ADDENDUM 2

DATE: December 1, 2023
 COMM NO: 23070
 PROJECT: **Renovations and Additions to Commonwealth Building Materials**
 1735 Plantation Rd NE
 Roanoke, VA 24012

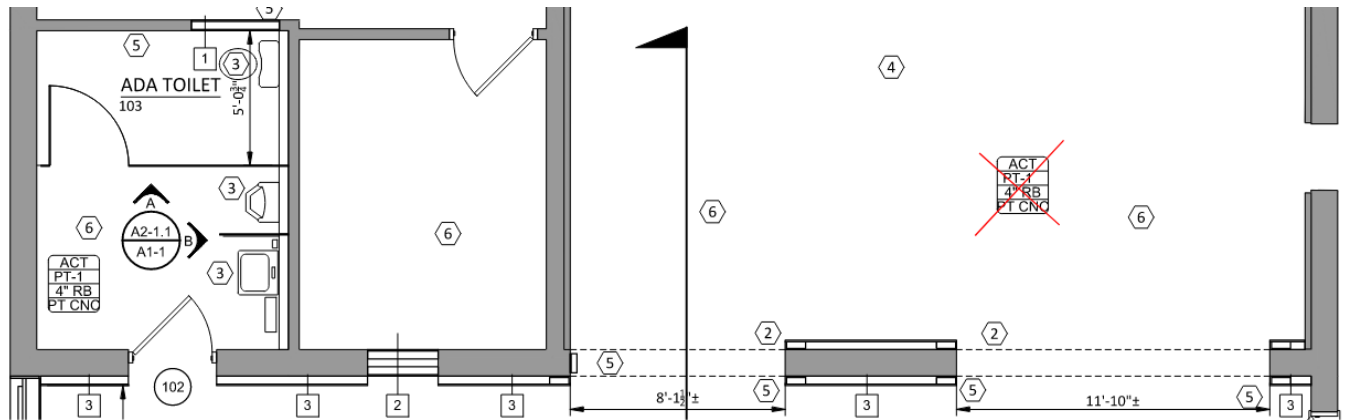
- Sheet AD-1, Note 4:** Plan AD-1.4 indicates the Luxury Vinyl Plank flooring, base and ceiling in the existing showroom being removed up to a dashed line near the existing sales counter. Delete Notes 4 and 5, from the entire existing sales area. Sales area flooring, base and ceiling are to remain. Notes 4 and 5 remain at the office/future toilet room.

Front of the building, looking toward the rear of the building

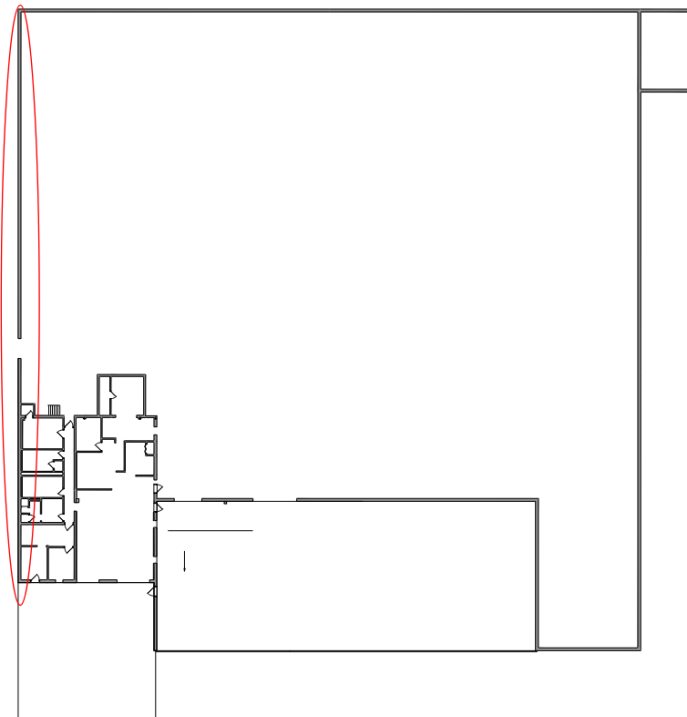
3. **Sheet A1-1, New Work Plan:** Indicates all floor areas to receive concrete paint and 4" rubber base. Change the concrete floor paint to surface applied concrete floor stain, color: green.
4. **Sheet A1-3, New Work Roof Plan:** Note indicates continuing the new sloping downspout to discharge beyond the rear building corner. This is due to poor drainage at this side of the building. The distance from the front of the existing building/joint with new addition, to the back of the existing building is 208 feet measured horizontally. Please note that window glazing on this side was identified as containing 4% Chrysotile, Category II Non-Friable. The sloping downspout route will need to be coordinated with exterior wall elements shown on next pages. Addendum continues on page 4.
